IREDELL COUNTY HEALTH DEPARTMENT

IMPROVEMENT PERMIT / CERTIFICATE OF COMPLETION / OPERATION PERMIT / EXISTING SYSTEM INSPECTION

PROPERTY DESCRIPTION NO. 17469 DATE 12-22-93 TAX MAP NO. 8K-10-A-3 Watershed: ☐ Yes ☑ No

LOCATION I-40W TL Old Mtn. Rd TR Warren Estates (Pleasant Dr.) 1st Lot on L.

INITIAL SITE SKETCH (See attached for pump diagram and pressure manifold diagram)

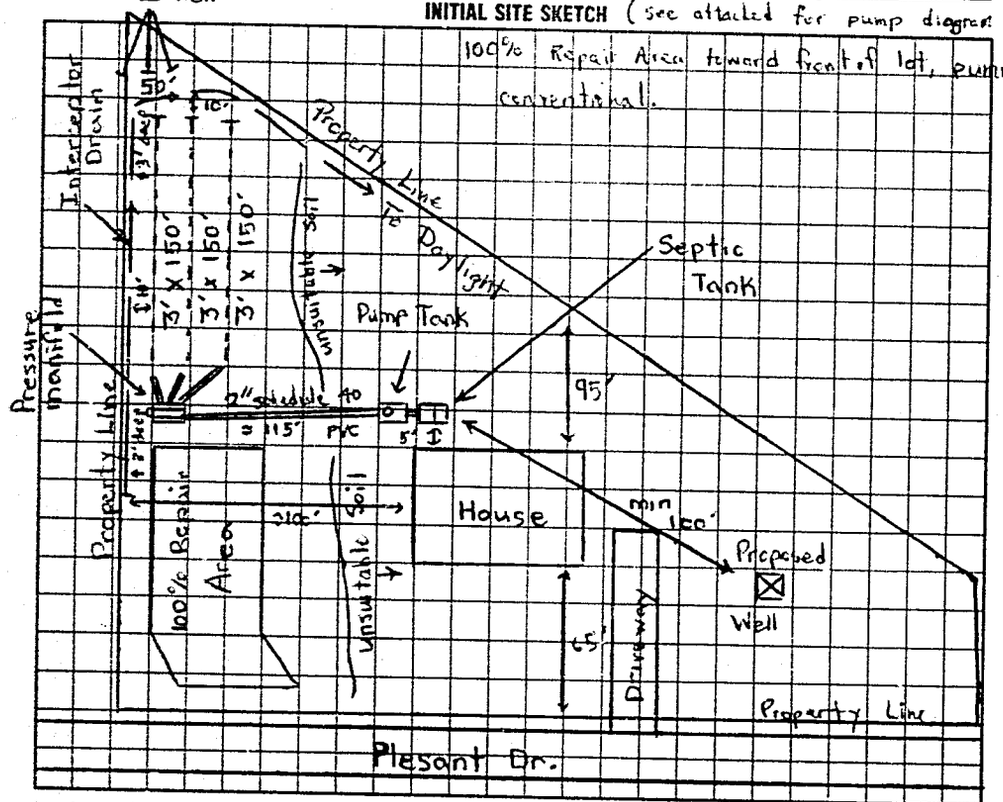
Comments: Pump to pressure manifold. INSTALL SYSTEM SHALLOW (no deeper than 15" to trench bottom) Keep Nitrification Lines on contour. Install interceptor drain around septic system, min. 3' deep and gravel up to 6" to surface, run to daylight. Install pump that will deliver 36 gpm at 16.07 TDH

Comments: 1st line of system installed too deep (36" to trench bottom) Pulled pipe and gravel out and filled back in. Sloped down from it and installed system. Caught installer after only first line (36" to trench bottom) was installed. Pushed system down the hill approx 5'. Inspected drain pressure manifold, Alarm, floats, NEMA 4X Box on 11-29-94 Also inspected tanks on 11-3-94 Inspected interceptor drain on 11-8-94. It was only 2½' deep and part of it was no 10' from drain lines. They will re-do and call back. Re-Inspected Interceptor drain on 11-13-94 JCM

SAME AS INITIAL SKETCH

* except system is 5' further down hill due to improper installation of 1st line.
